Addison Urban District Plan Review
1995

Addison Urban District (SA# 41532)

Concept Plan Review

Re: Addison Circle - Preliminary Plat/Construction Plans

Category H - Mildred Street West of Rotary

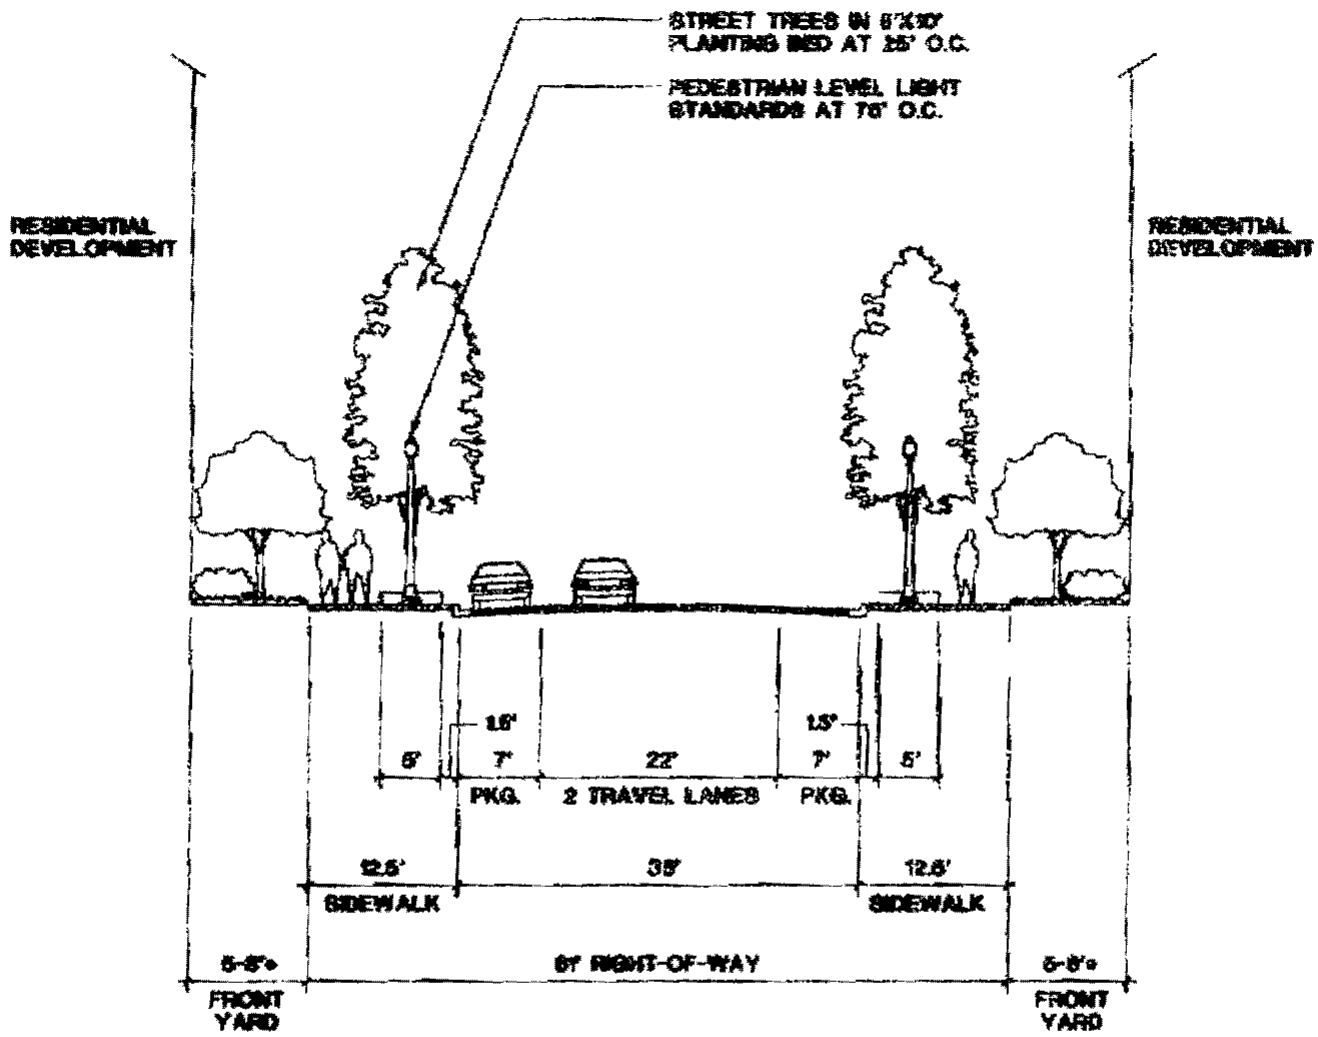
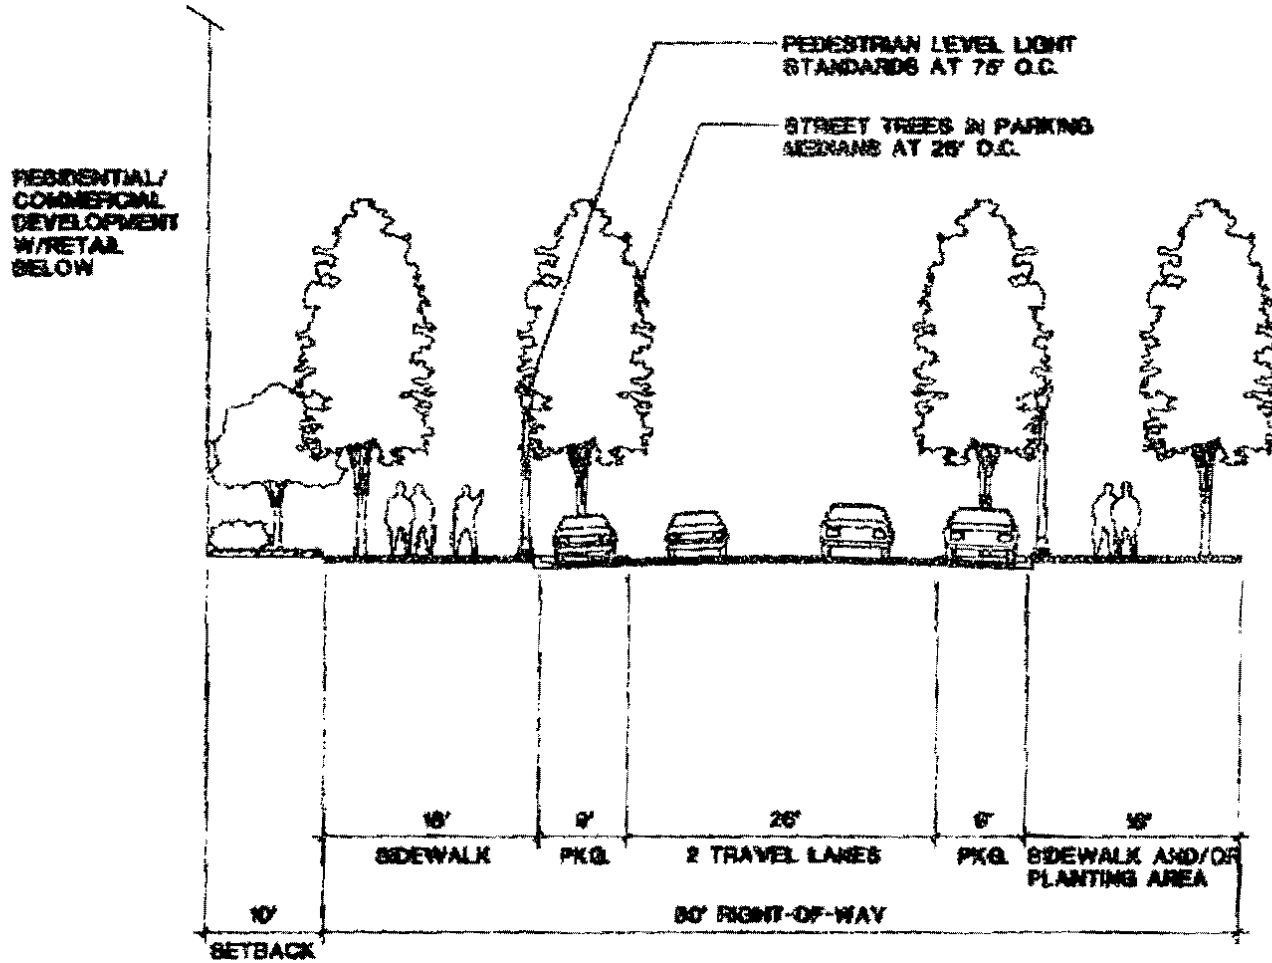
- Zoning ordinance indicates four travel lanes (44' excluding parking) for the Mildrid Street section west of the Rotary. The applicant has reduced the section to 45' including parking which reduces the roadway to two travel lanes. Sasaki has no objections to this change as long as the applicant can verify that two travel lanes would be sufficient for anticipated traffic volumes, including off-site traffic, (i.e. Addison Theatre/Conference), and an acceptable transition between the existing Mildrid and the new cross section can be developed
- Neckdowns" on Sections G and H should be increased to 9'.

- **Section H:** We have made the sidewalk the same size on both sides of Mildred.
- **Section G & H:** Increased parking and "neckdown" from 7.5' to 9'.

B. Intersection of Residential Street with Mews

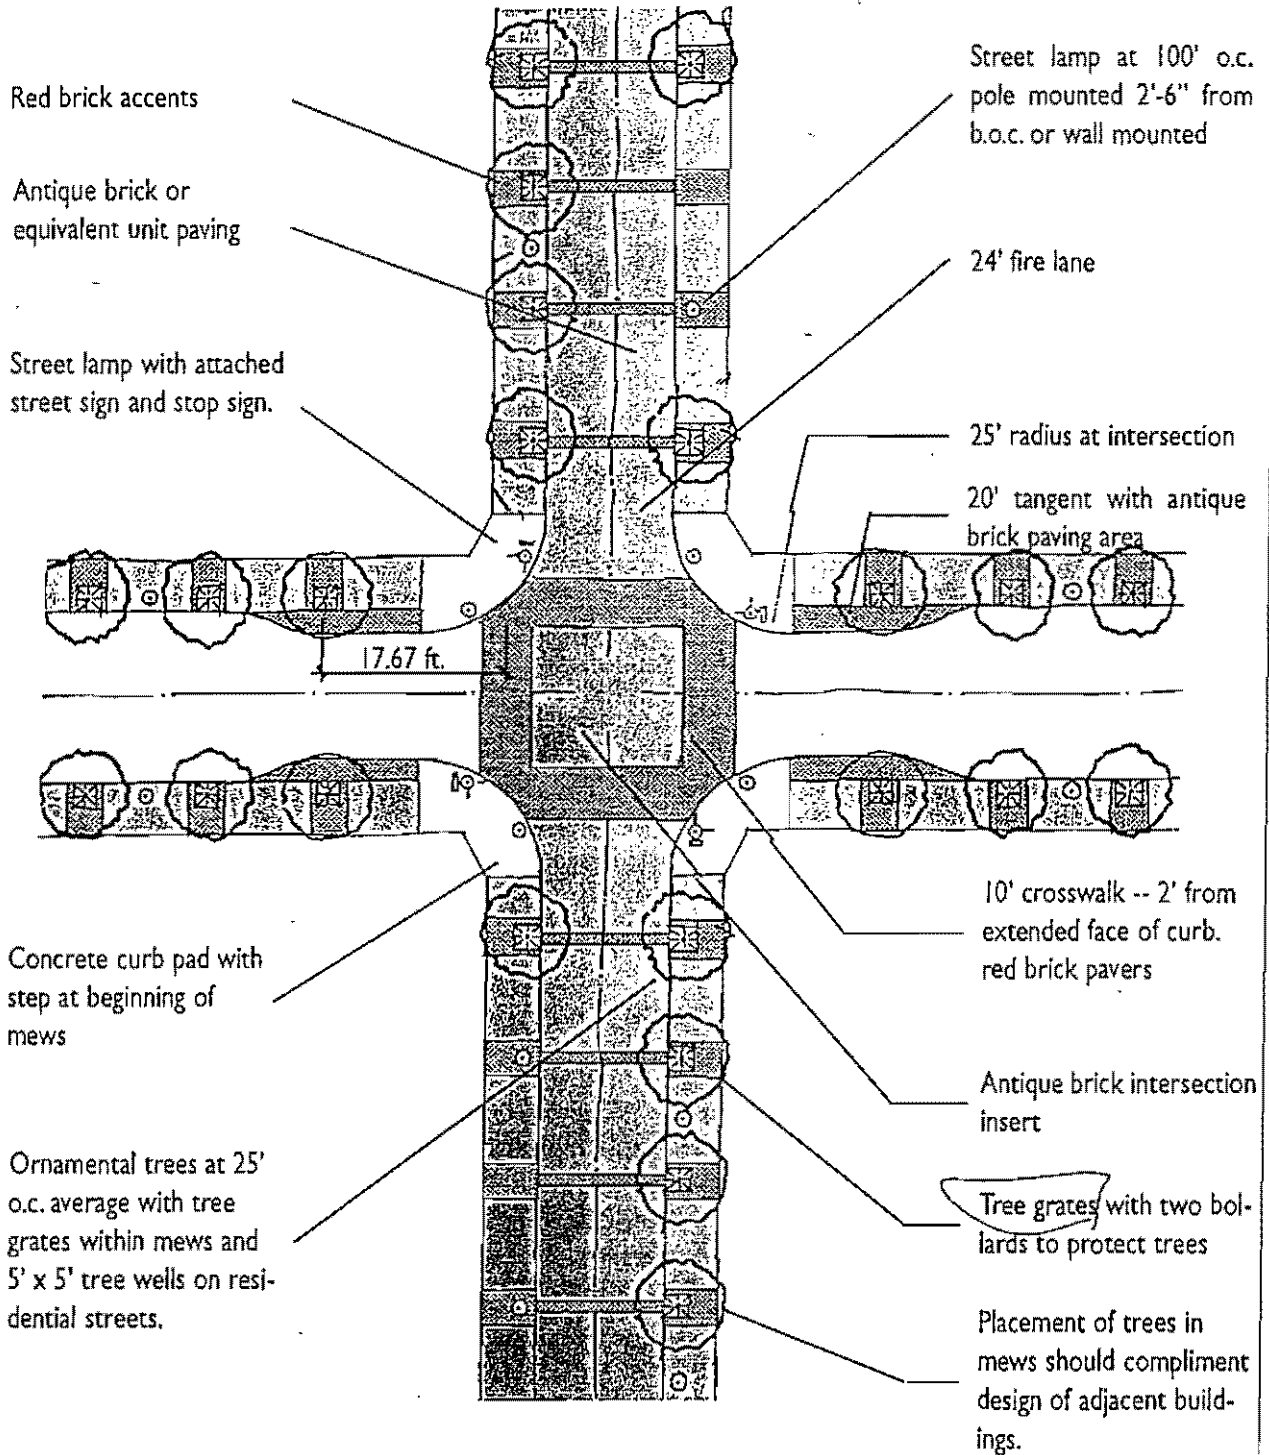
Not antique brick
